SUBJECT: Electric Substation Audit of PG&E San Carlos Headquarters

Enclosure: CPUC Electric Substation Audit Report for PG&E San Carlos Headquarters

CPUC SUBSTATION AUDIT FINDINGS
PG&E SAN CARLOS HEADQUARTERS
FEBRUARY 24-28, 2025

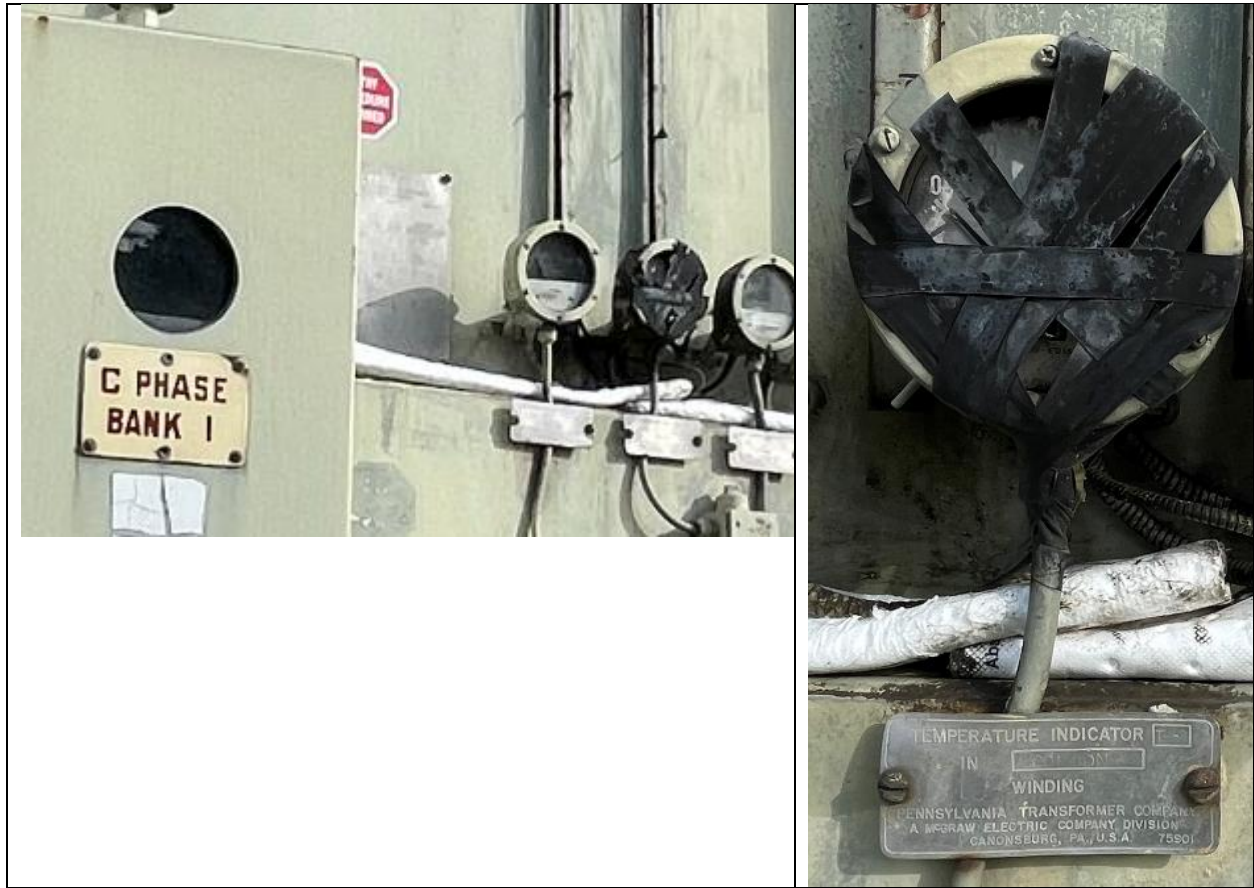
16.2. A hole in the bottom of the circuit breaker 172 cabinet was open, but it was sealed by PG&E during the audit.

16.3. Circuit breaker 182 has a damaged counter. PG&E indicated it has an existing LC notification for this issue, #130876429.

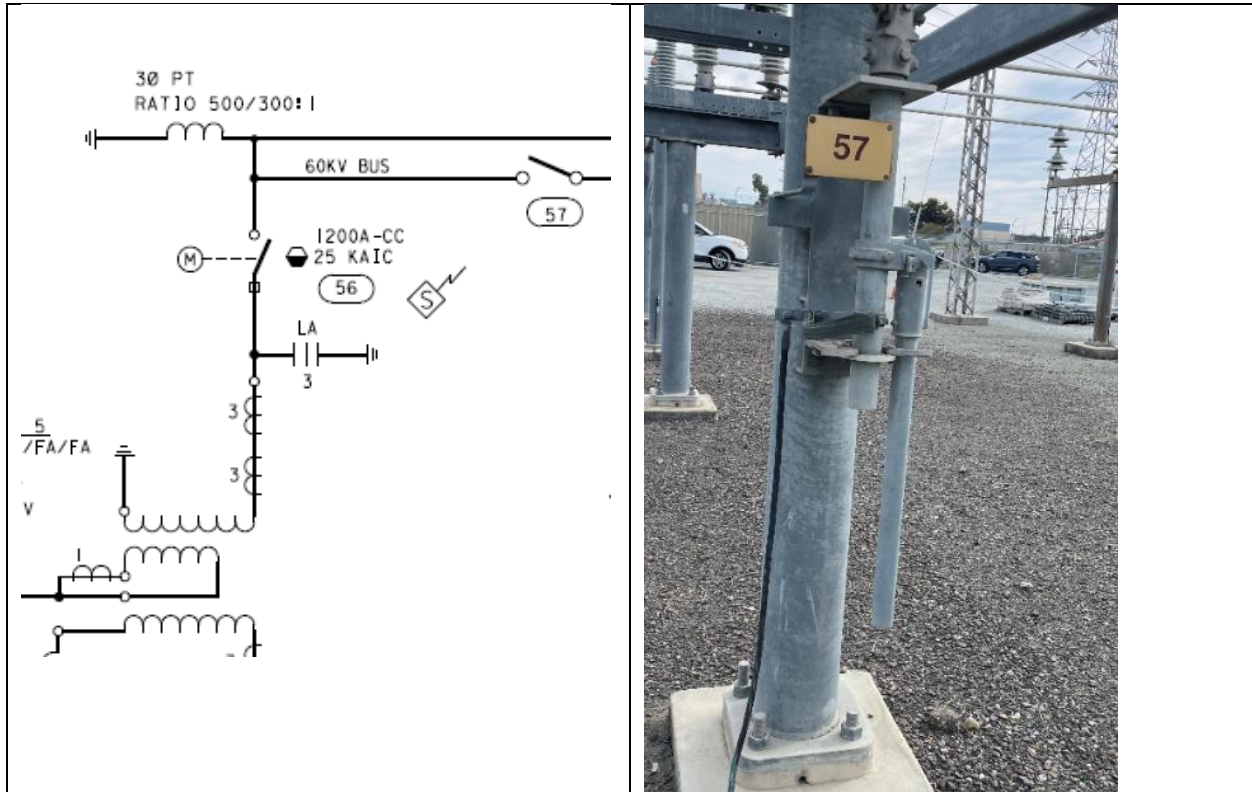
17.1. Circuit breaker 14 has a faded semaphore for the closed position and a damaged semaphore for the open position.²¹

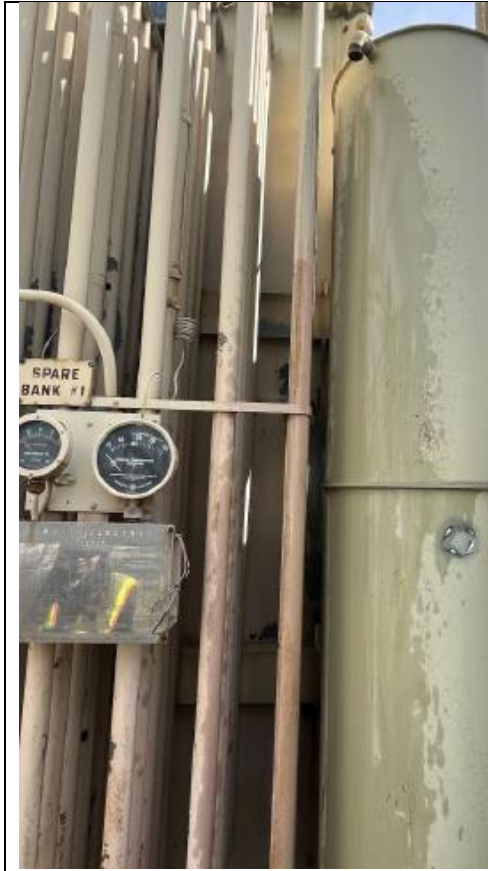
17.4. The spare transformer for transformer bank 4, labeled “Spare Bank#1,” has a winding temperature gauge that isn’t working and has loose wires coming out of it, as well as an electrical box that is missing a cover and exposing wires. PG&E indicated it has an existing LC notification for this issue, #130805230.

17.5. The spare transformer for transformer bank 4, labeled “Spare Bank#1,” vented oil onto the pad during the audit. Clean up was in process during the audit.
